Re: Pitt Meadows Road and Rail Improvements project;
Kennedy Road overpass pedestrian and cycling facilities

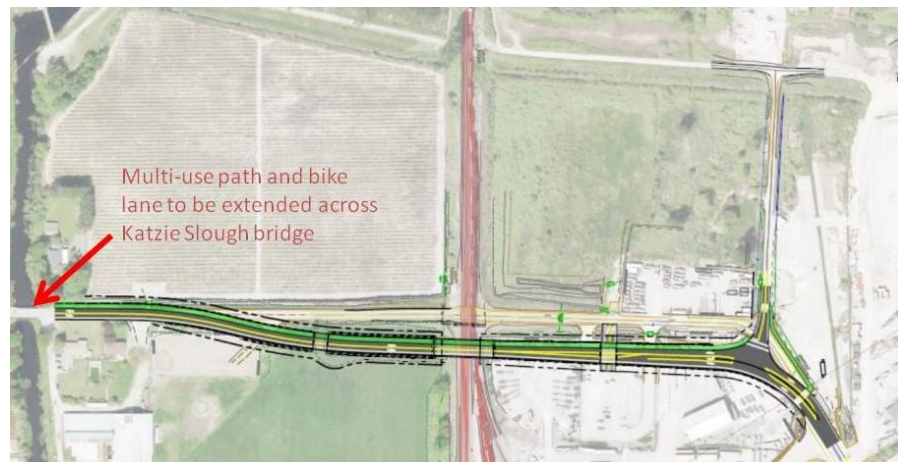
Kennedy Road tends to be used by road cyclists, whereas the existing multi-use path, Ferry Slip Road and the dike trails are generally the preferred route for recreational cyclists. However, as the trail underpass under the rail bridge is closed during high water conditions, the Kennedy Road route needs to be safe for people on bikes of all ages and abilities (AAA). Closure of the trail underpass is expected to happen more frequently and for longer periods of time due to rising water levels as a result of global warming.

We are pleased to hear that the **usable** width of the planned multi-use path on the west side of Kennedy Road will be at least 4 meters.

As Kennedy Road is a designated truck route, we feel that physical separation between motor vehicles and users of the multi-use path is important.

For the same reason, the width of the east side bike lane needs to be 1.8 meters wide with at minimum a 0.3 m buffer¹.

We would like to see both the multi-use path and the bike lane extended to include the bridge crossing of the Katzie Slough as well as the remaining section of Kennedy Road up to the dike access path. This would complete a safe alternate route for all ages and abilities during times that the railroad underpass is not accessible.

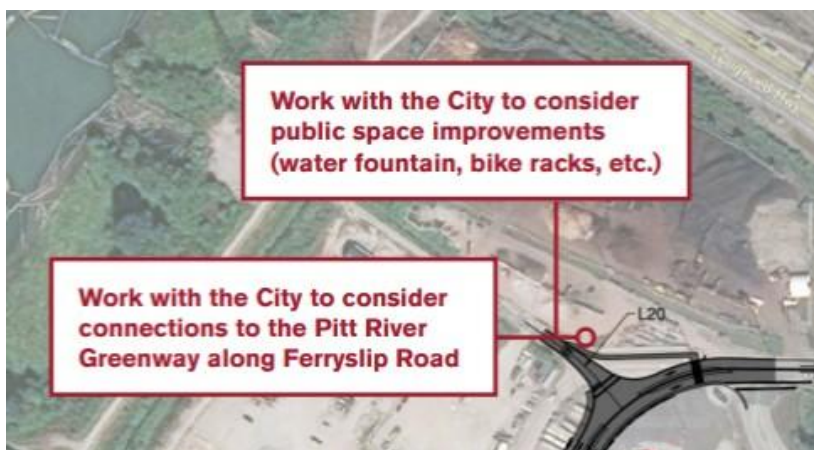
The ample road right-of-way along the section of Kennedy Road running north-west to south-east allows for the road to be pushed to the south, thus creating enough width for the multi-use path:

On the north side, the MUP on the west side of Kennedy Road lines up well with the existing multi-use path at Ferry Slip Road and provides good dike access.
